NOTICE OF DECISION

CLASS 3 SITE PLAN REVIEW / CLASS 2 ADJUSTMENT CASE NO.: SPR-ADJ22-23

SUMMARY: A request to redesign the required pedestrian pathway for an existing building.

LOCATION: 3514 Commercial St SE, Salem OR 97302

1 SITE PLAN

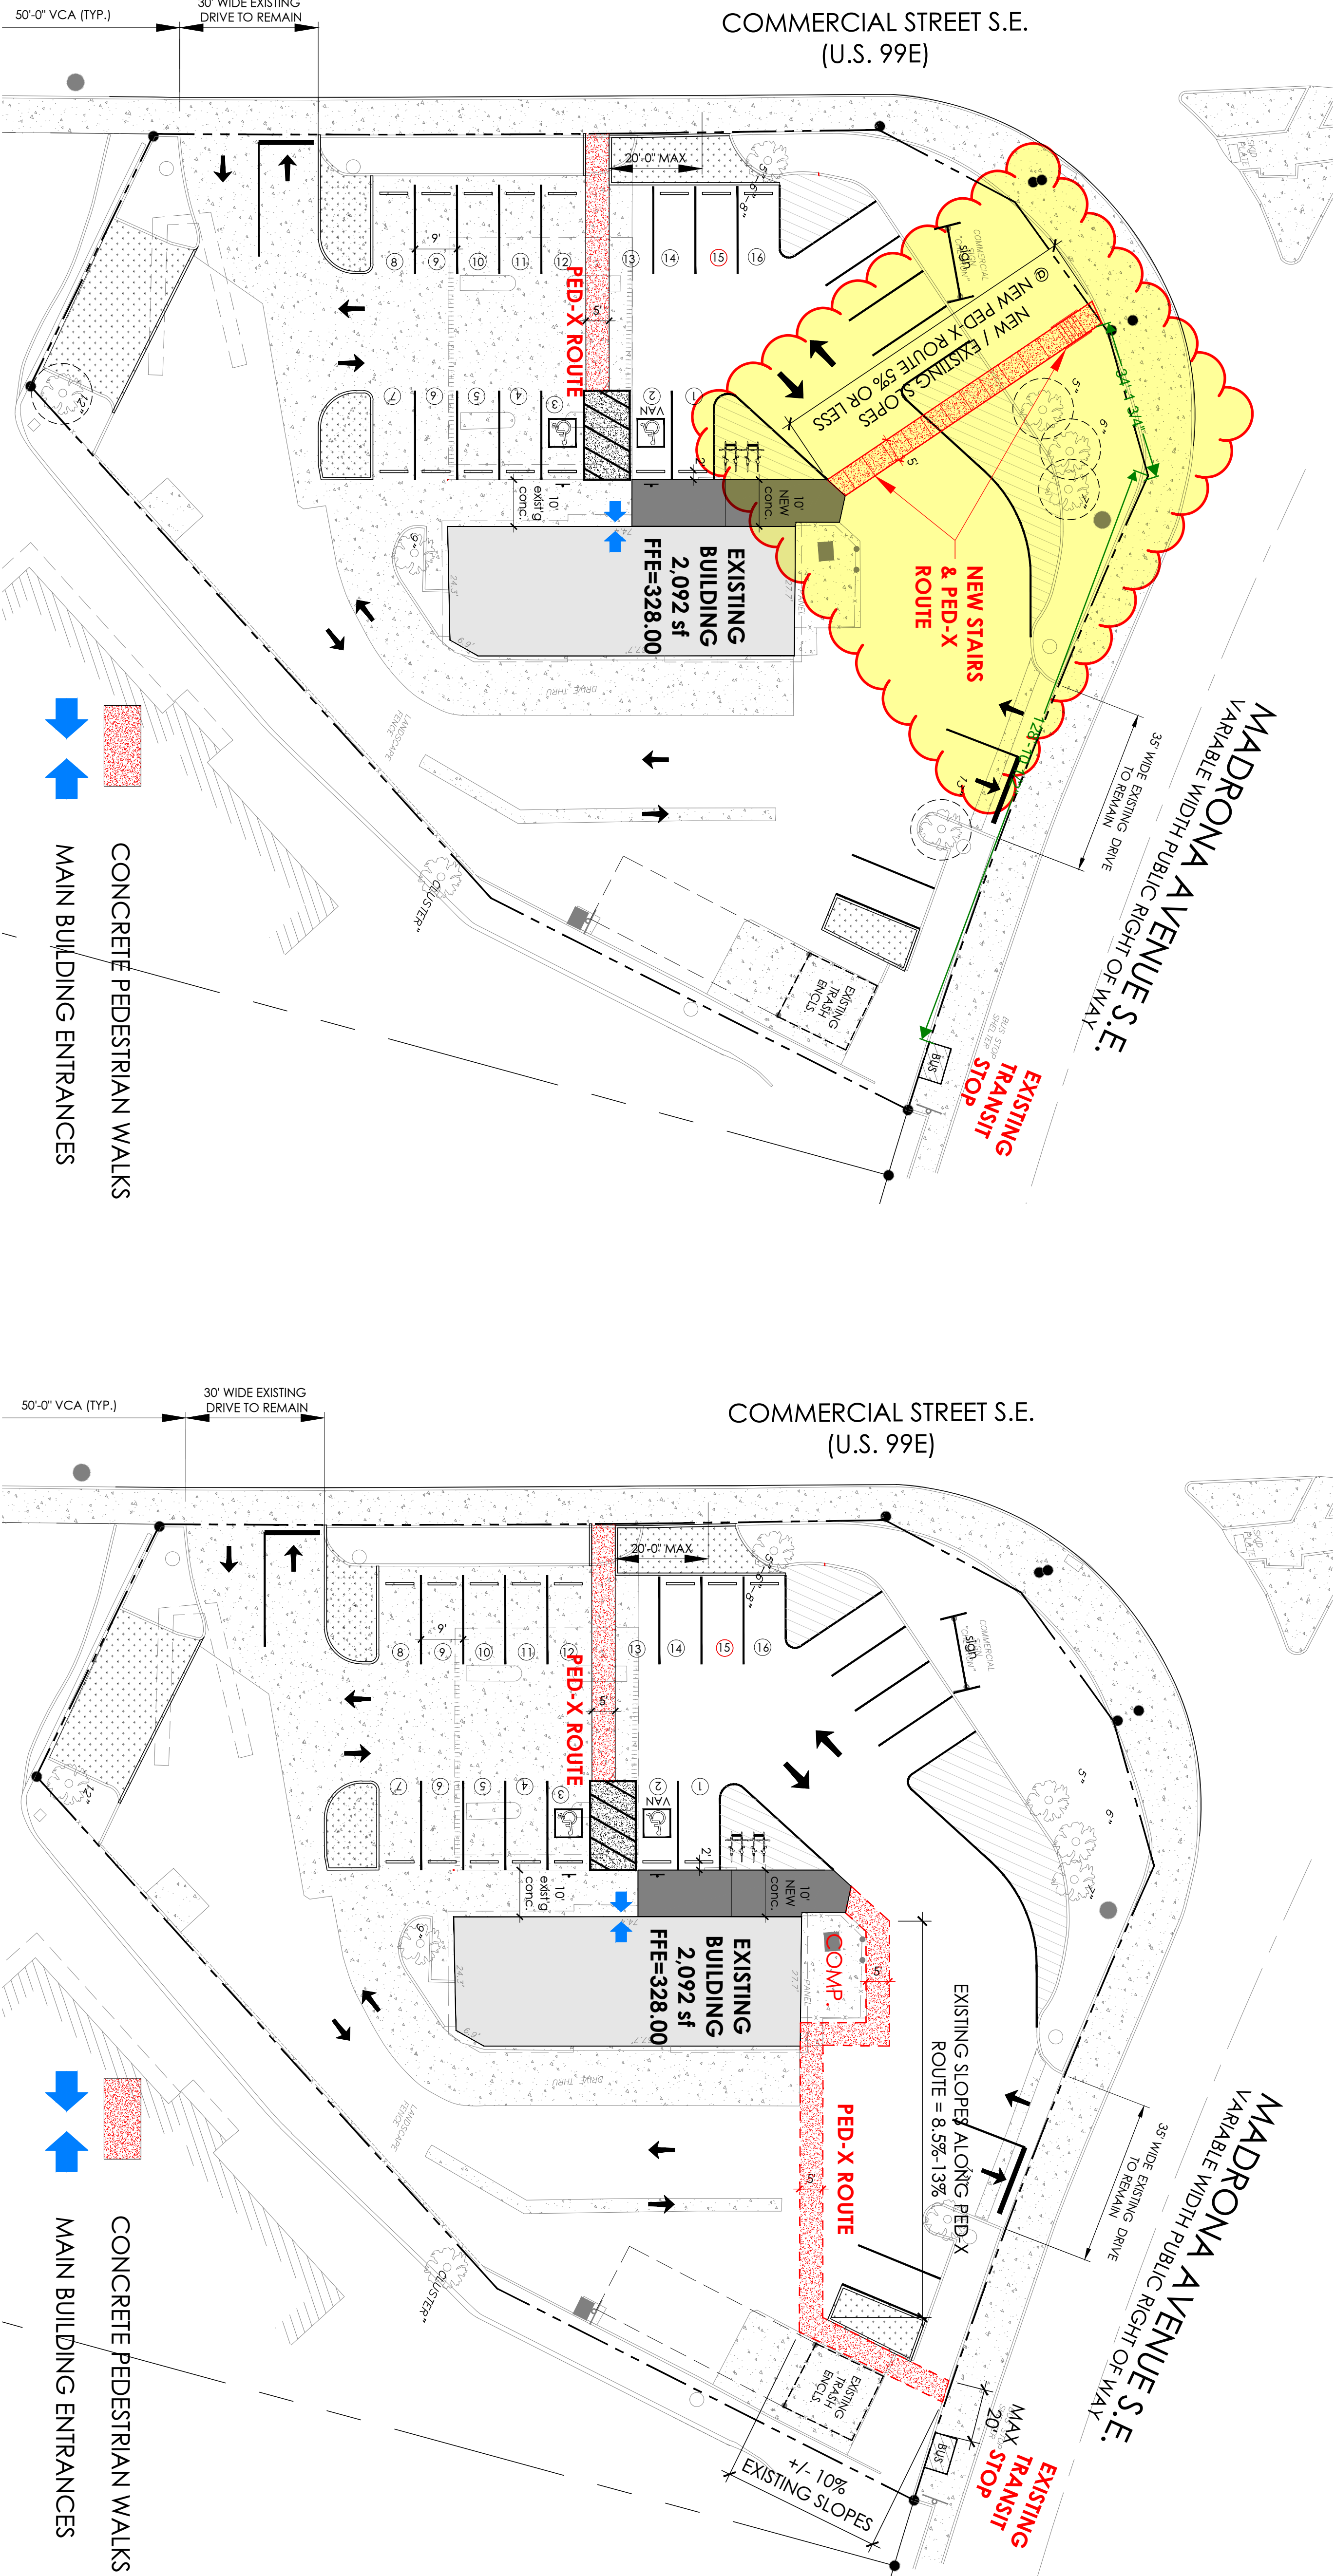
Notice of the proposal was provided to public agencies and to public and private service providers. Cherriots bus service provided a comment that indicated concern with the ADA accessibility of the proposed stairway. This comment is included as **Attachment D**.

Applicant's Statement: As currently approved, pedestrians would be required to walk down a newly constructed steep sidewalk ramp (+/- 10%) from the backside of public sidewalk Transit Stop. This is also challenging due to the proposed sidewalk needs to meet up flush with existing public sidewalk street elevation that continues to climb heading east Madrona Ave SE.

Pedestrians would then walk across a severely sloped driveway with average slopes of 8.5%-13% from the furthest point of the property and proceed to walk behind the building and maneuver around a 6-foot-high building compressor screen wall with

limited visibility to onsite vehicle traffic. This path lacks the safe traveling environment for pedestrians to building front door thus putting the location undesirable thus the request for an adjustment to the code.

The adjustment request re-locates this pedestrian connection to the northwest corner of the site along the public sidewalk (See exhibit A) allows for any new concrete sidewalks to constructed with slopes 5% or less, which is more desirable and comfortable for patrons to walk on. This new pedestrian route will provide a much safer environment for pedestrians to travel across a less-severe driveway and provide greater visibility of the surrounding vehicle traffic. This also provides a direct connection to the sidewalk at the front door of the business. A second pedestrian connection has also been provided to the business front door from Commercial Street SE.

Finding: The applicant is requesting a Class 2 Adjustment to allow an increase to the distance from a transit stop to approximately 165 feet from the required 20 feet. The reason for the standard to require a pedestrian connection within 20 feet of a bus stop is to allow people utilizing the transit system an efficient and convent route to adjacent properties.

This site is unique because of the slope leading from the west side of the site to east side is steep at 8.5-13%. The applicant is proposing to add a different pedestrian route that would have a much lower 5% grade or less, though would include a set of stairs.

COMMENTS: Cherriots would support the redesign of the pedestrian pathway to an adjacent street submitted in this application if it did not include stairs. The stairs shown in the redesigned pedestrian pathway drawings would not be ADA accessible for individuals using mobility devices. Cherriots requests that the redesign include an ADA accessible ramp or other alternative instead of stairs. If the pathway cannot be redesigned to include a ramp or other alternative, Cherriots requests that the adjustment to allow an increase in the distance from the transit stop on Madrona Ave SE to the pedestrian pathway from 20 feet to 165 feet be denied and the original pedestrian pathway design be built.

The site is still accessible via a pedestrian route along Commercial Street that is flat and has no stairs. With both pedestrian accessways through the site, pedestrians can choose which route is most convenient.

Condition 2: The adjusted setbacks, as approved in this zoning adjustment, shall only apply to the specific development proposal shown in the attached site plan. Any future development, beyond what is shown in the attached site plan, shall conform to the applicable development standards, unless adjusted through a future land use action.
